Service Bulletin No. 155
FAA DOA EA-4 Approved

Date: July 30, 1976
Subject: Bondline Protection

Serials Affected:	AA1, AA1A's	0001 & Sub.
	AA1B	0001 thru 0641
	AA5's	0001 & Sub.
	AA-5A	0001 thru 0173
		0176 thru 0196
	AA-5B	0001 thru 0309
		0311 thru 0324

FIGURE 1

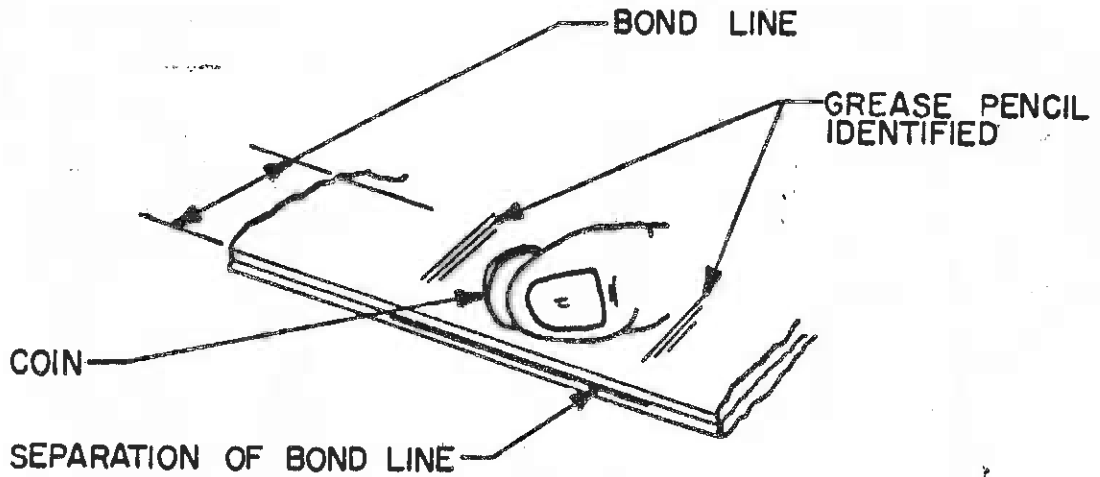
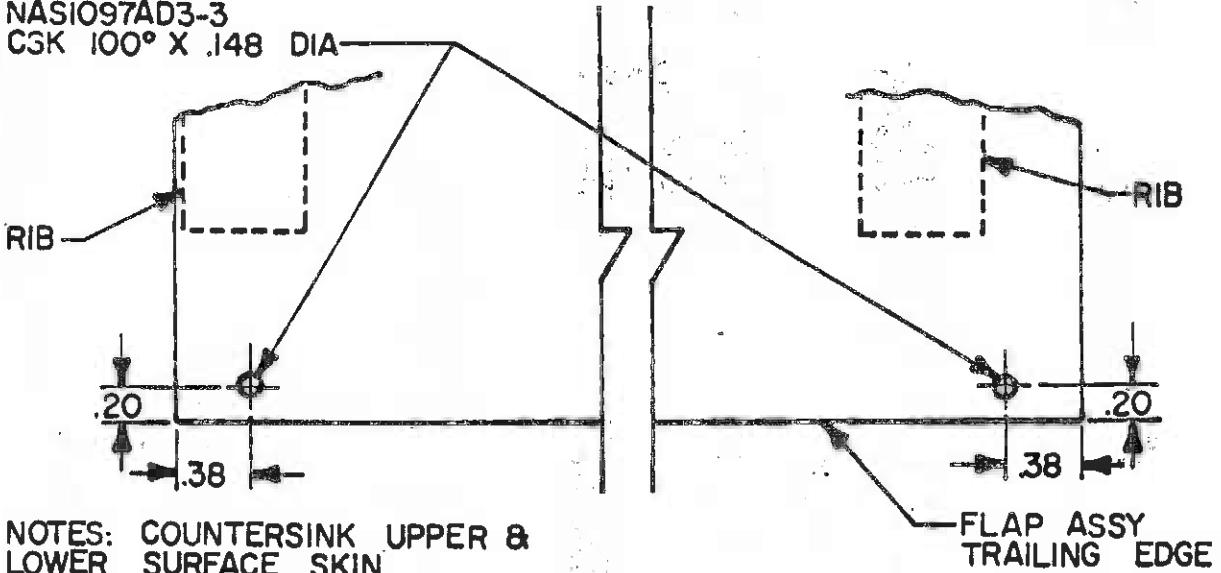
- A. Carefully scan the edges of all joints in a well lighted hangar or outside in daylight to determine the existence of hairline cracks between two layers of bonded metal. Figure 1 shows the appearance of this condition. Identify the location of any cracks with a grease pencil as shown in Figure 1.

- E. Flap Rework - AA1 0001 and Sub., AA1A 0001 and Sub. and AA1B 0001 - 0579.
 1. Drill .097 - .102 Dia. Hole in outboard and inboard ends of flaps. (See Figure 1). Countersink holes 100° x .148 Dia. Both sides of hole. Care should be used when countersinking, so as not to take out too much material.
 2. Install NAS1097AD3-3 Rivet, wet with zinc chromate primer (MIL-P-8585). Rivet shall be flush both sides.

- F. Flap Rework - AA5 0001 and Sub., AA5A 0001 - 0179 and AA5B 0001 - 0293.
1. Drill .097 - .102 Dia. Hole in outboard and inboard ends of flaps. (See Figure 1). Countersink holes 100° x .148 Dia. both sides of hole: Care should be used when countersinking, so as not to take out too much material.

.097-.102 DIA
 NAS1097AD3-3
 C3K 100° X .148 DIA

NOTES: COUNTERSINK UPPER & LOWER SURFACE SKIN.
 INSTALL ALL RIVETS WET USING ZINC CHROMATE PRIMER MIL-P-8585.
 MS20470AD3- RIVET MAY BE SUBSTITUTED FOR NAS1097AD3-3.

FIGURE 2

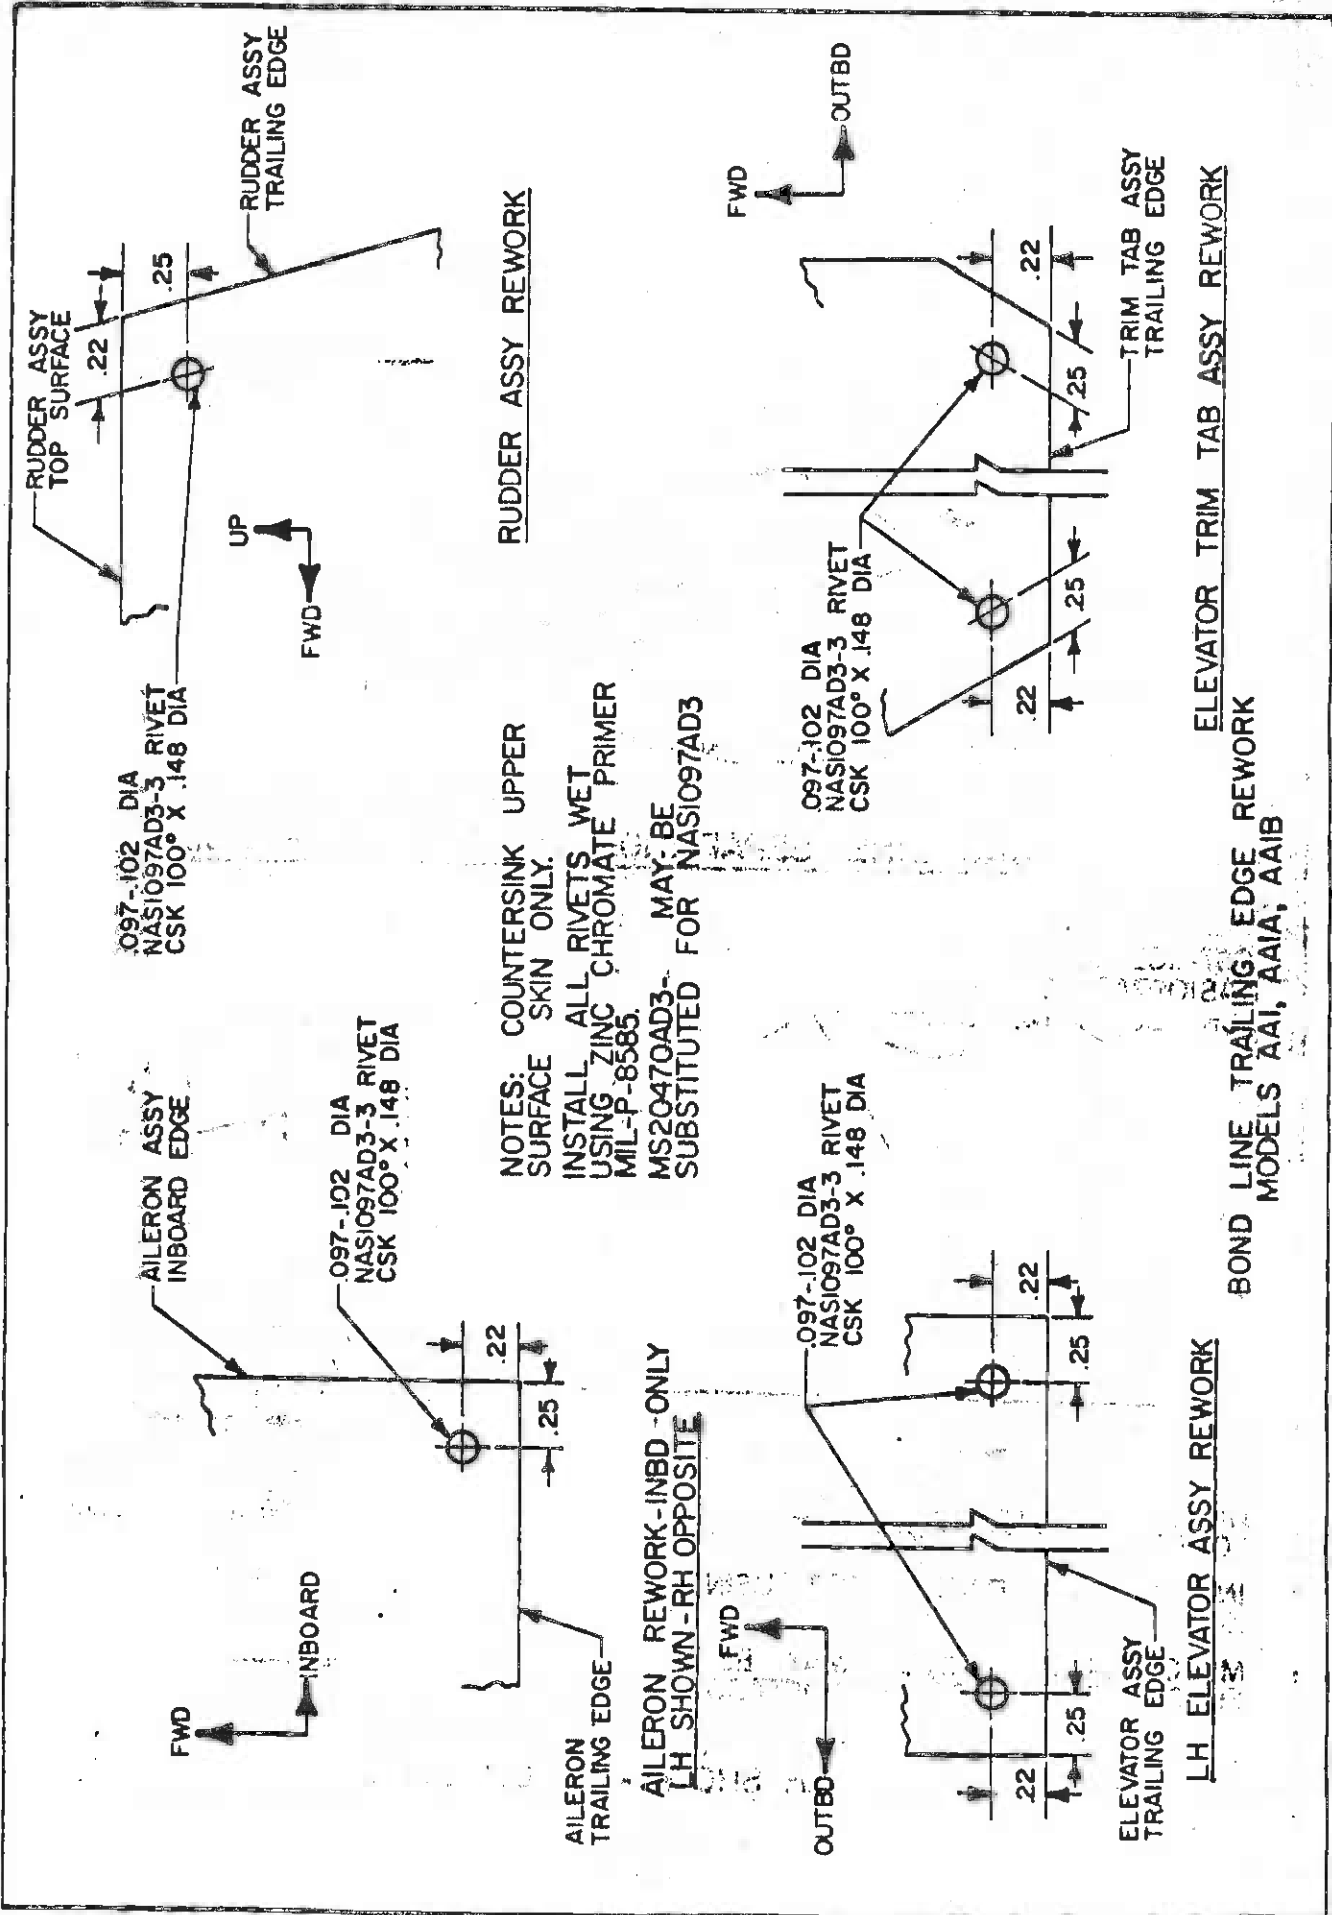
1. On inboard of end of ailerons drill .097 - .102 Dia. Holes (See Figure 2). Countersink hole 100° x .148 Dia. on upper surface skin only. Install NAS1097AD3-3 Rivet, wet with zinc chromate primer (MIL-P-8585).

2. On inboard and outboard end of elevator trim tab, drill .097 - .102 Dia. Hole (See Figure 2). Countersink holes 100° x .148 Dia. on upper surface skin only. Install NAS1097AD3-3 Rivet, wet with zinc chromate primer (MIL-P-8585).

3. On top of rudder drill .097 - .102 Dia. Hole (See Figure 2). Countersink hole 100° x .148 on L/H side only. Install NAS1097AD3-3 Rivet wet with zinc chromate primer (MIL-P-8585).

4. On inboard and outboard end of L/H elevator drill .097 - .102 Dia. Holes (See Figure 2). Countersink holes 100° x .148 Dia. on upper surface skin only. Install NAS1097AD3-3 Rivet, wet with zinc chromate primer (MIL-P-8585).

FIGURE 2

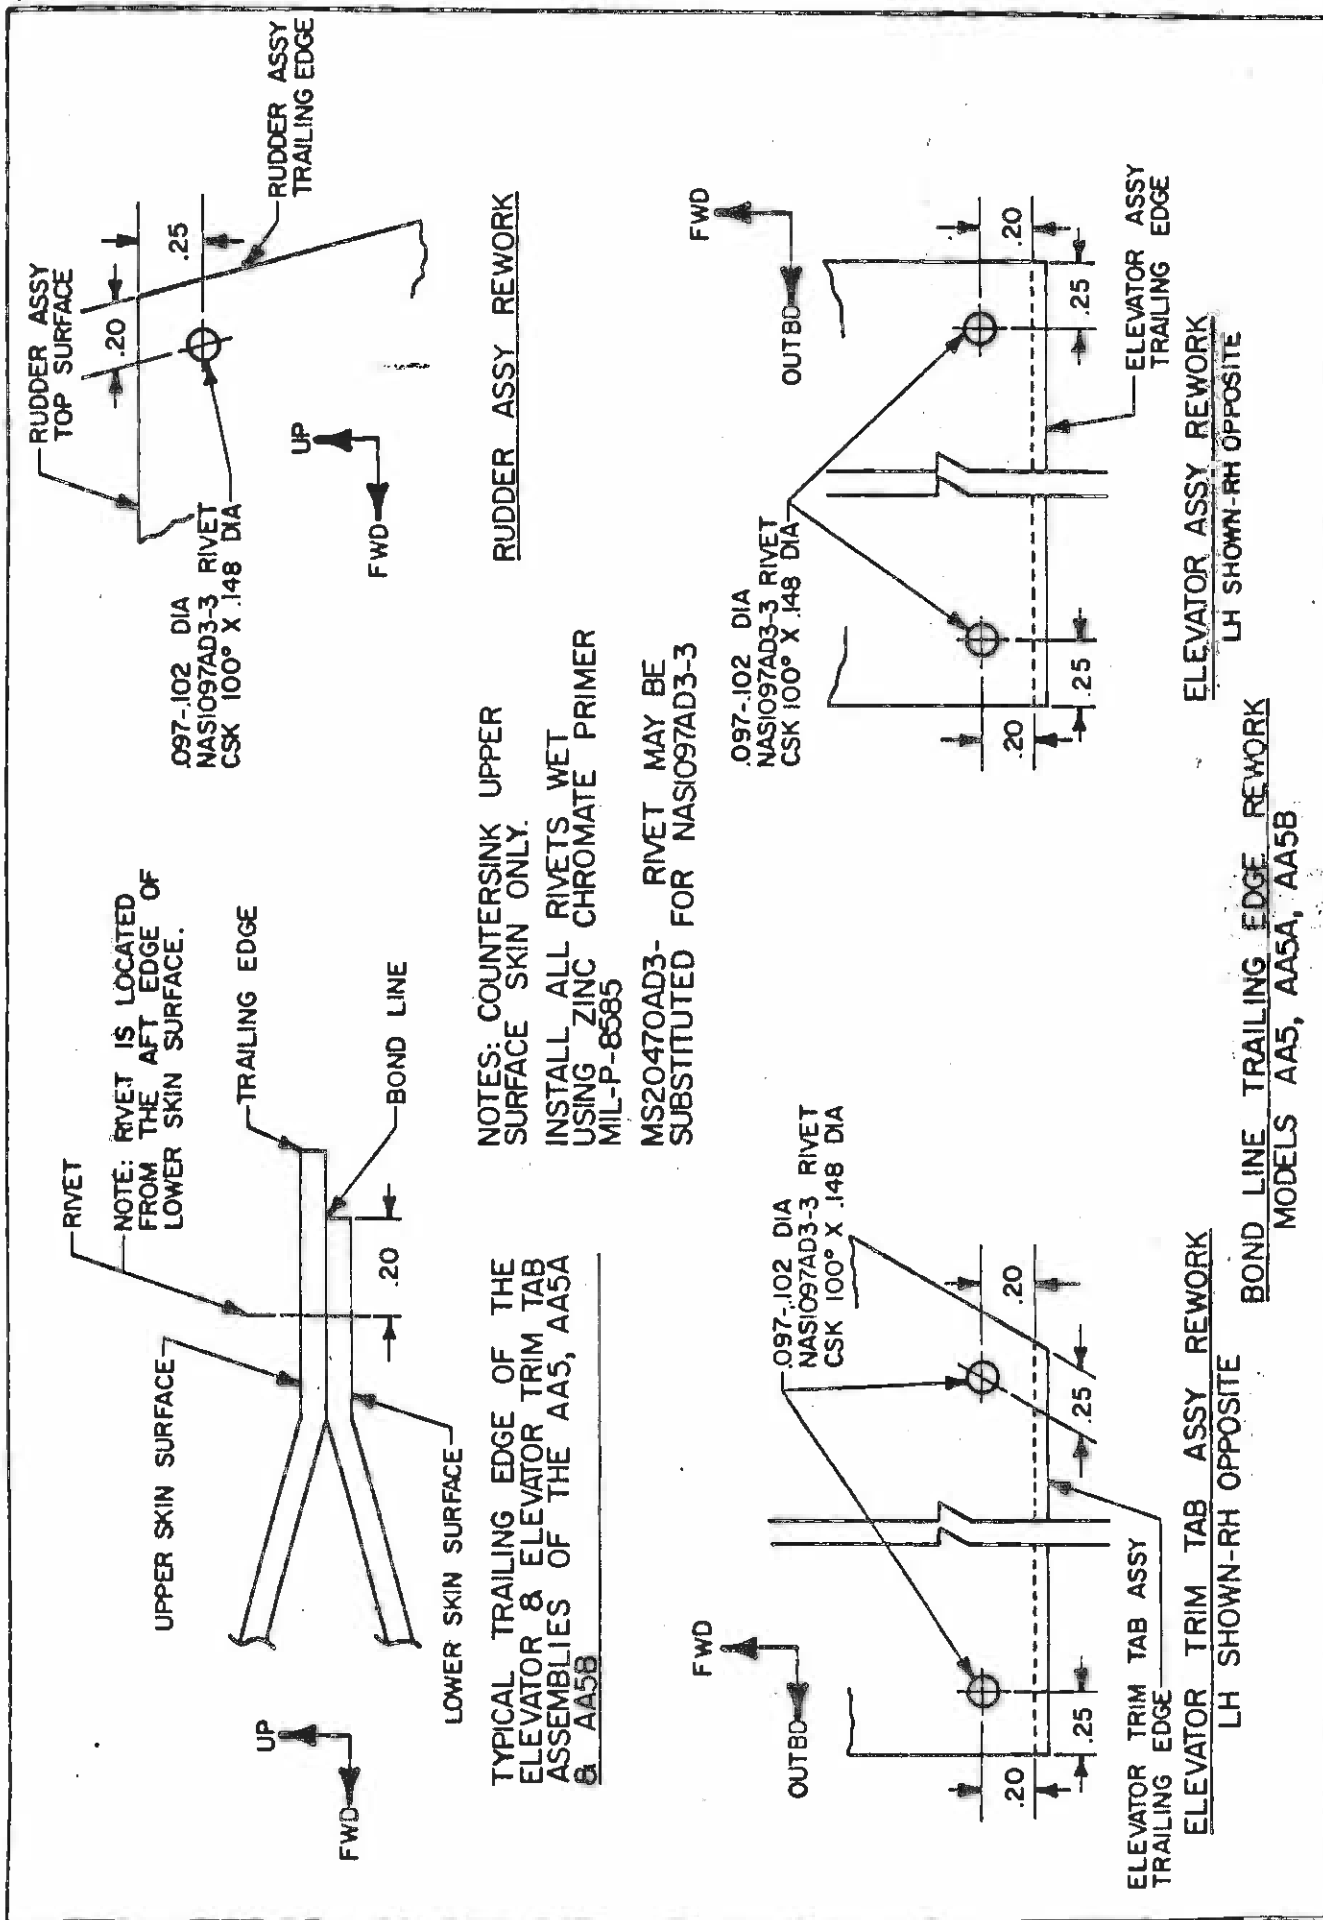
- H. Bondline trailing edge rework - AA5, AA5A and AA5B.
1. On top of rudder drill .097 - .102 Dia. Hole (See Figure 3). Countersink hole 100° x .148 on L/H side only.

2. Install NAS1097AD3-3 Rivet, wet with zinc chromate primer (MIL-P-8585).
 3. On inboard and outboard ends of elevator trim tab drill .097 - .102 Dia. Hole (See Figure 3). Countersink holes 100° x .148 Dia. on upper surface skin only. Install NAS1097AD3-3 Rivet, wet with zinc chromate primer (MIL-P-8585).

4. On AA-5A and AA-5B elevators drill .097 - .102 Dia. Hole in both elevators in inboard and outboard ends. Countersink holes 100° x .148 Dia. on upper surface skin only. (See Figure 3). Install NAS1097AD3-3 Rivet, wet with zinc chromate primer (MIL-P-8585).
